**RE: 4th & Montano Dental Office  
Grading and Drainage Plan  
Engineers Stamp Date 7/6/15 (F14D055)**

**RE: 4<sup>TH</sup> AND MONTANO DENTAL OFFICE  
GRADING AND DRAINAGE PLAN (F14-D055)**

RONALD R. BOHANNAN P.E. #7868	<b>4TH ST AND MONTANO DENTAL OFFICE</b>	DRAWN BY DY
	<b>GRADING AND DRAINAGE PLAN</b>	DATE 6/30/15
 <b>TIERRA WEST, LLC</b> 5571 MIDWAY PARK PLACE NE ALBUQUERQUE, NM 87109 (505) 858-3100 www.tierrowestllc.com		2014099-GRE
		SHEET # <b>C3</b>
		JOB # 2014099

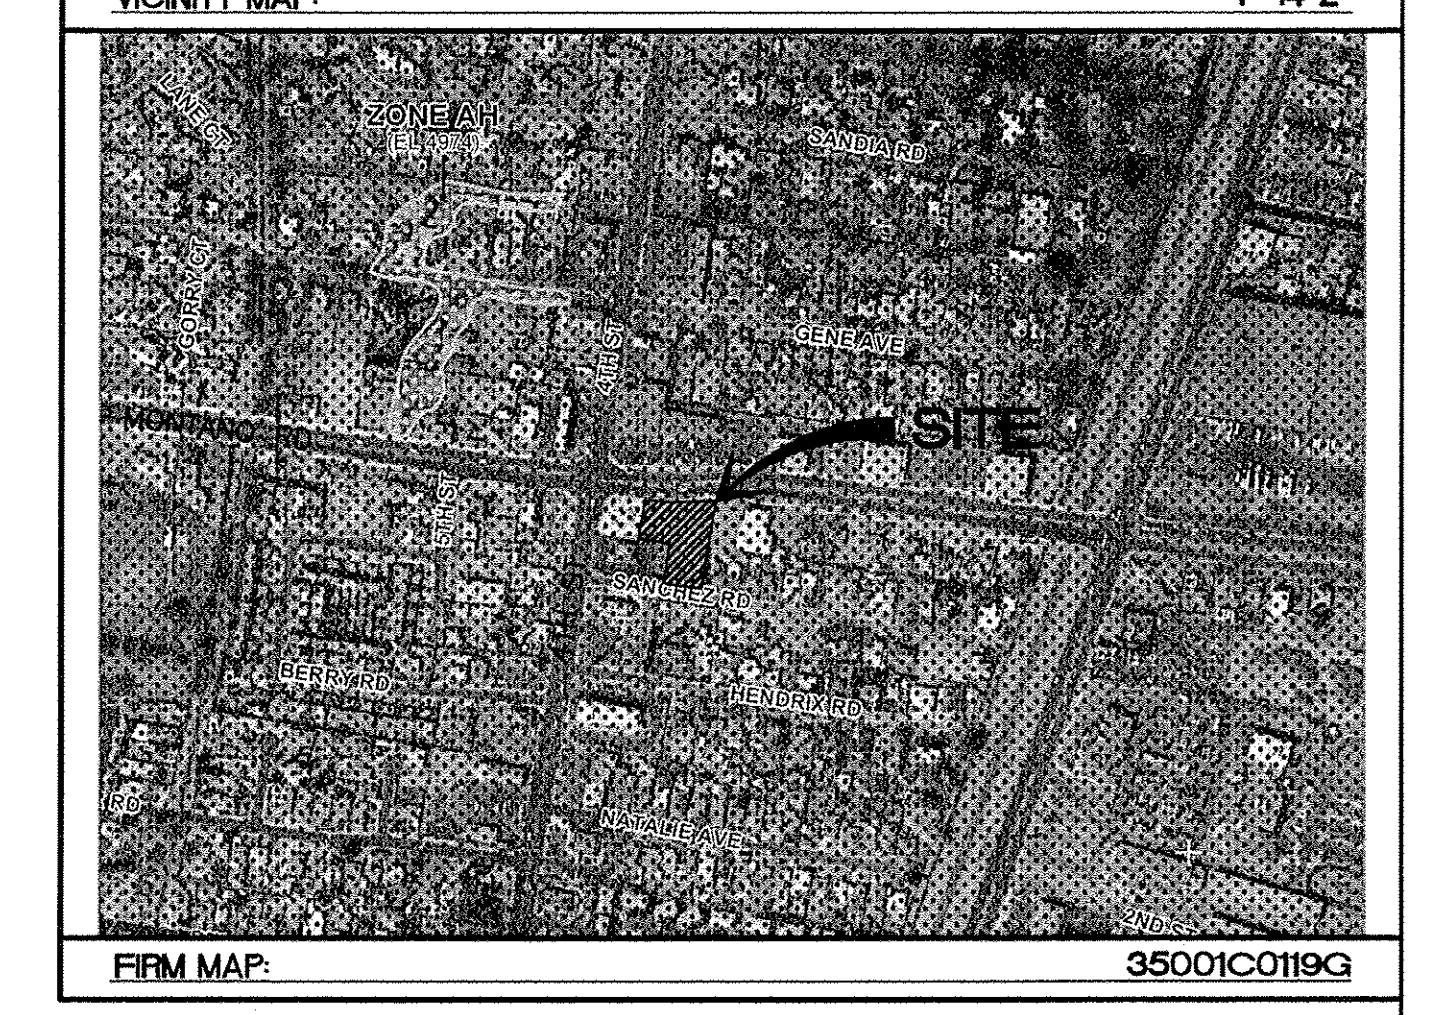
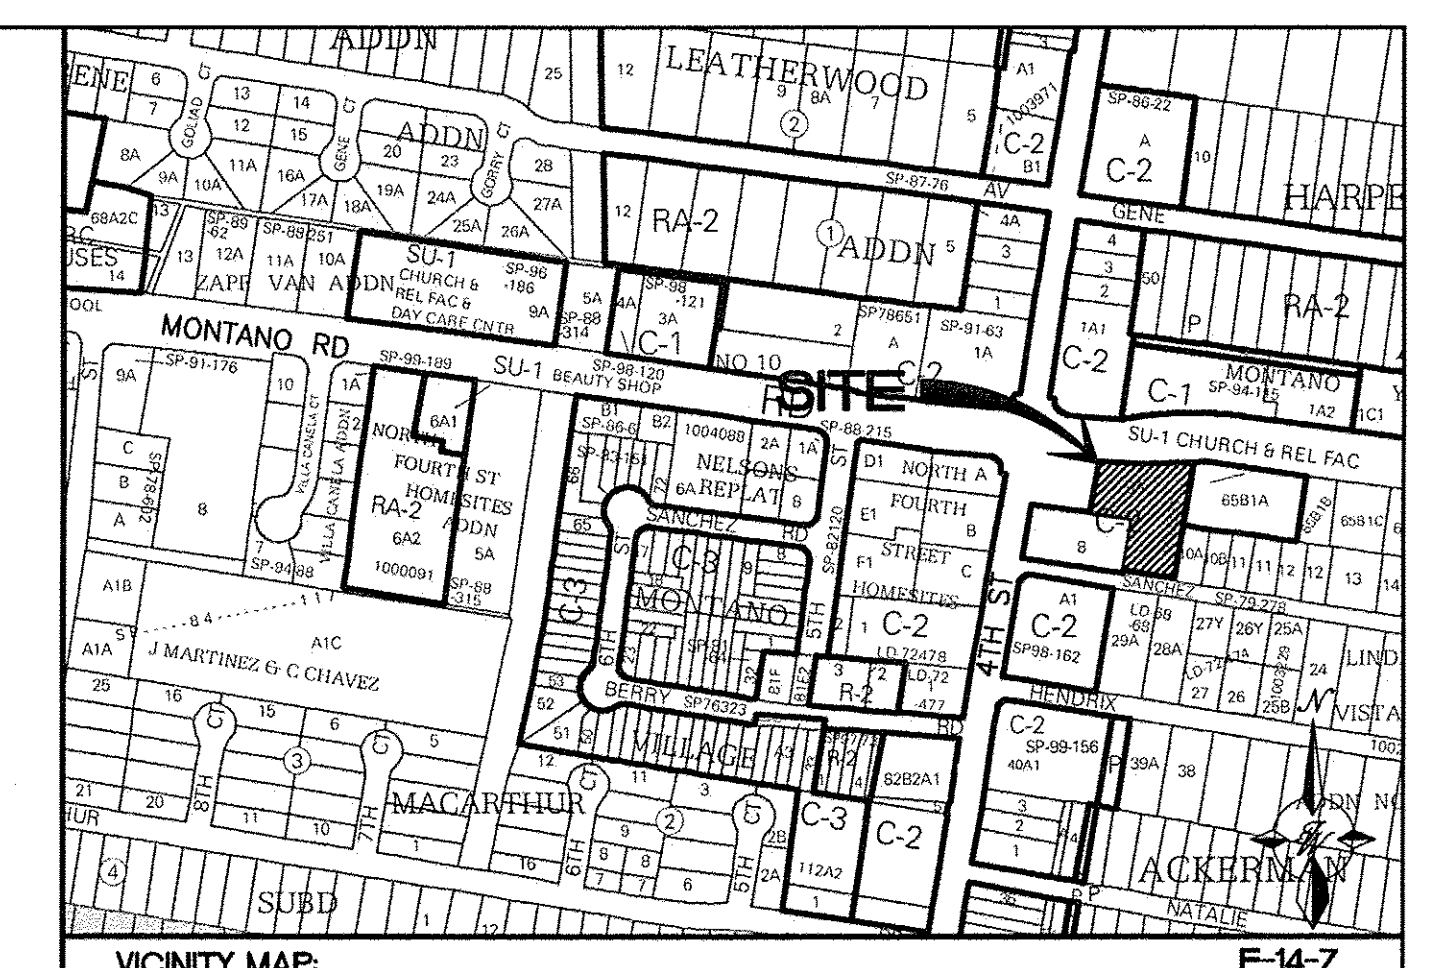
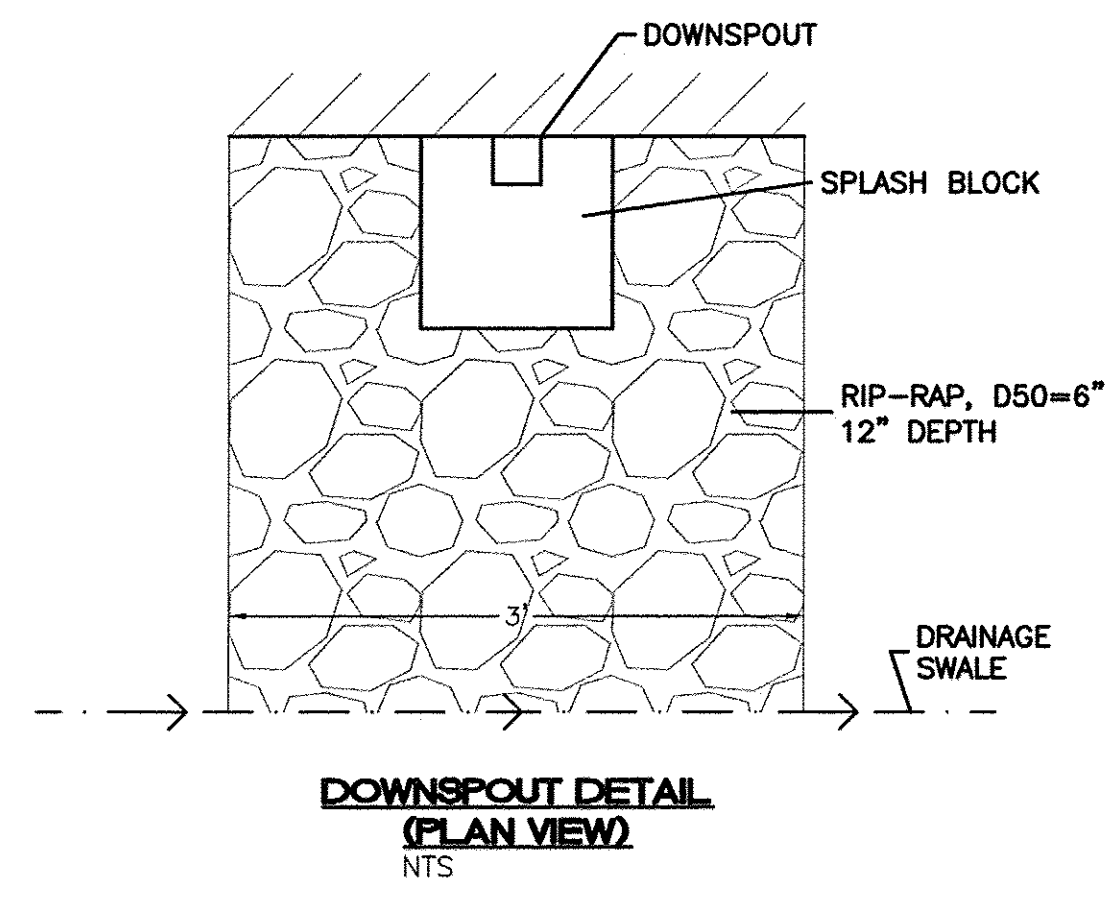
1. Are the west and south areas of the building landscaped?  
**Response: Yes they are landscaped.**
2. A cross lot drainage agreement is needed from the owners to the south.

3. Is curbing in place at the existing south parking area? If so, curb cuts will be needed.  
**Response: No. curbing is not in place in the existing south parking area.**

4. How are flows from the roof directed away from the building?  
**Response: Flows from the roof are directed to 3 down spouts on the west side of the building. These are indicated on the grading plan along with splash blocks. The runoff is captured in the drainage swale that runs along the west side of the building.**

5. What is the double line in the north landscaped area? Is this a sidewalk culvert?  
**Response: The double lines are existing contour lines. The sidewalk and concrete area along the north side of the building have been revised per comments from Planning to include a ramp and stair connection to the existing Montano Blvd sidewalk. The remaining area on the north side is now to be landscaped.**

**Response: Per discussion with Mr. Rael, additional information was added to the plan to show that a cross lot drainage agreement is not necessary as the drainage is maintained onsite.**
